REMARKS

AMENDMENTS TO THE DRAWINGS

Three (3) attached sheets of drawings include changes to Fig. 1B, 10A to 10C, and 14A and 14B. The changes to these Figures are as follows.

FIG.1B

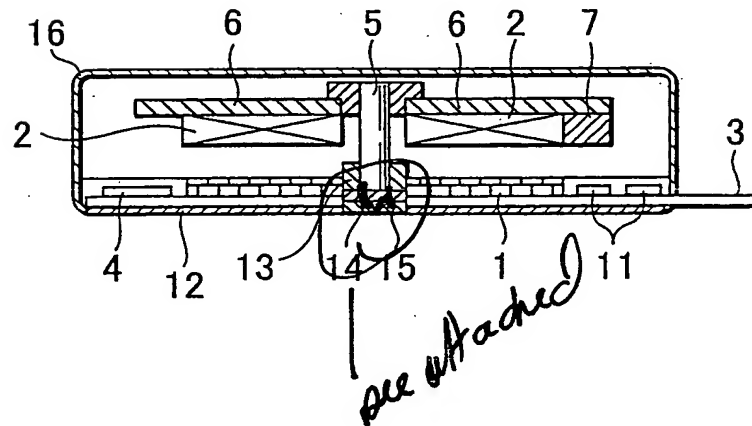
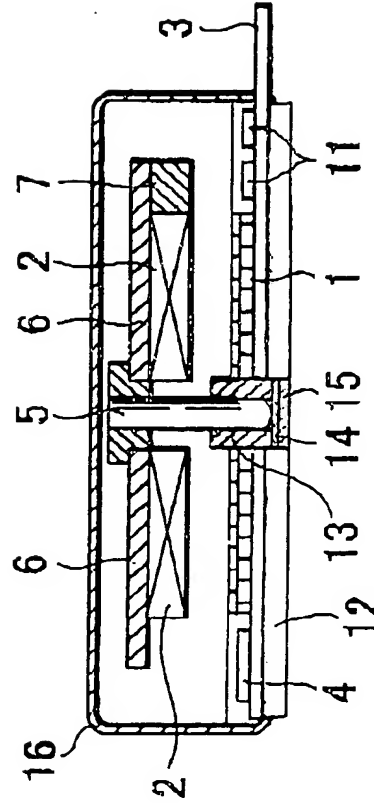
Sheet 1 includes Fig. 1B – the structure of the bottom plate 12, shaft 5, radial bearing 13 and thrust bearing 14 is harmonized with the method of manufacture, particularly as shown in Figs. 7 to 10, for example.

FIG.10A

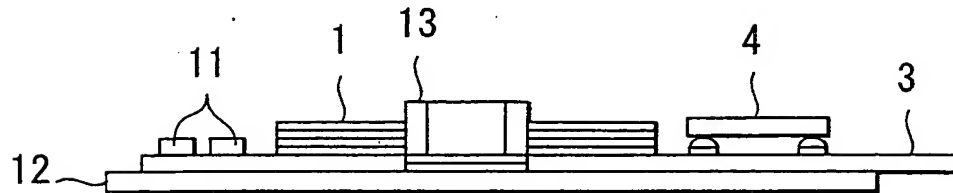
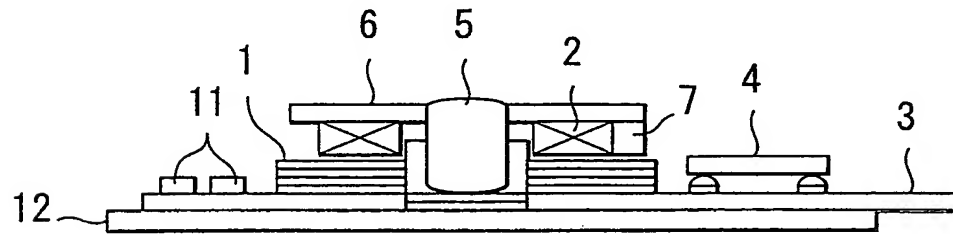
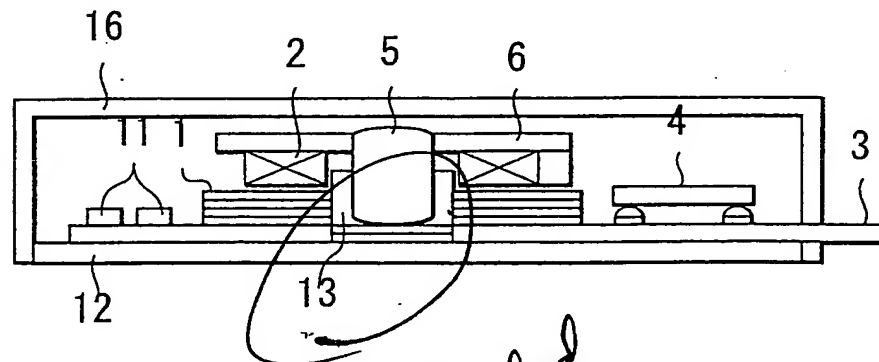
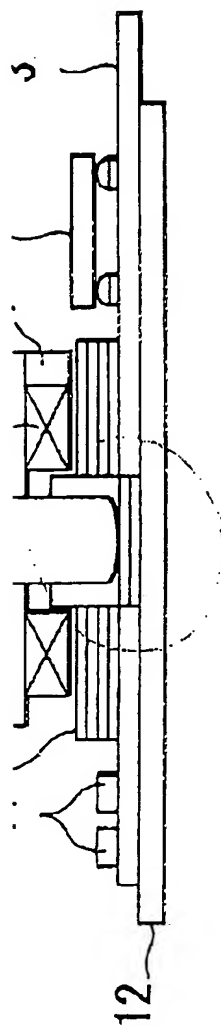
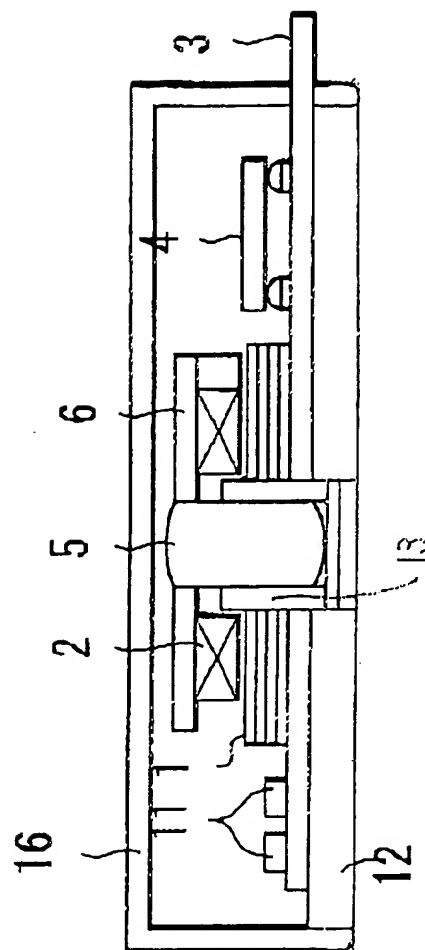
Sheet 2 includes Fig. 10A to 10C – the drawings are changed to show the shaft 5 and radial bearing 13 accurately relative to the bottom plate 12.

FIG.14A *Prior Art*

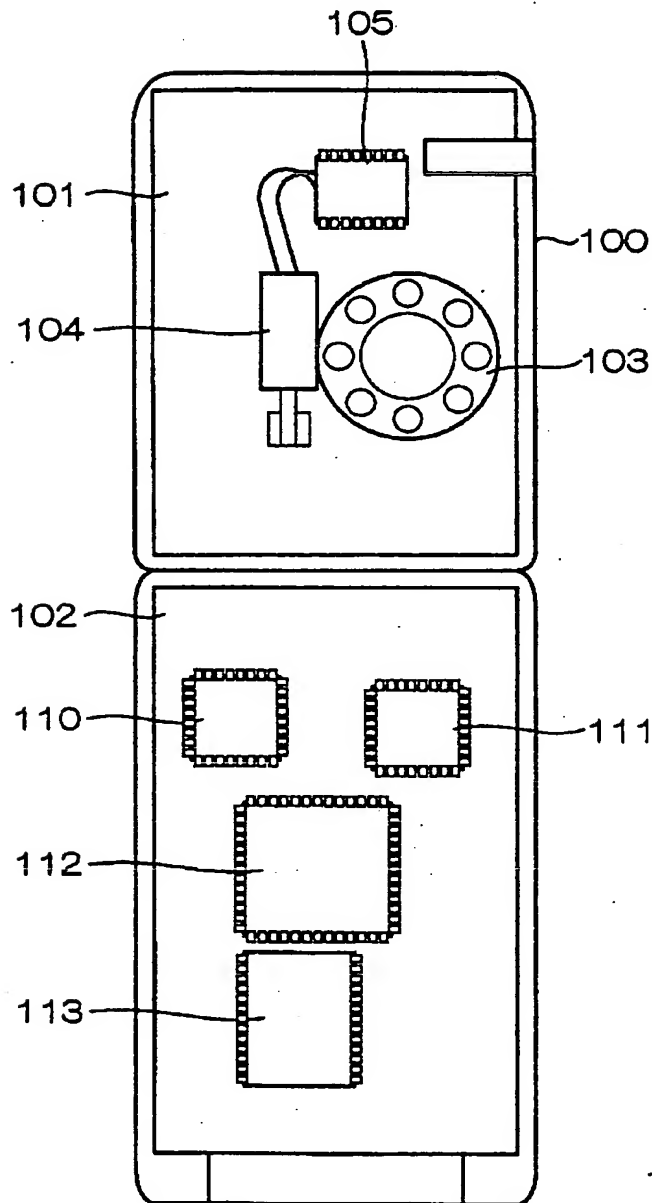
Changes are made to 1B, 10A to 10C and Fig. 14A and 14B as shown on the attached sheets. In particular, Fig. 14A and 14B has been amended to add the legend "Prior Art" as requested by the Examiner. This change is responsive to the points raised in section 4 on page 3 of the Action. Claims 4 and 5 are canceled and claim 3 included in claim 1 in a way that avoids the offending recitation of a motherboard.

Sheet 3 includes Fig. 14A and 14B – Please add the legend -- PRIOR ART --
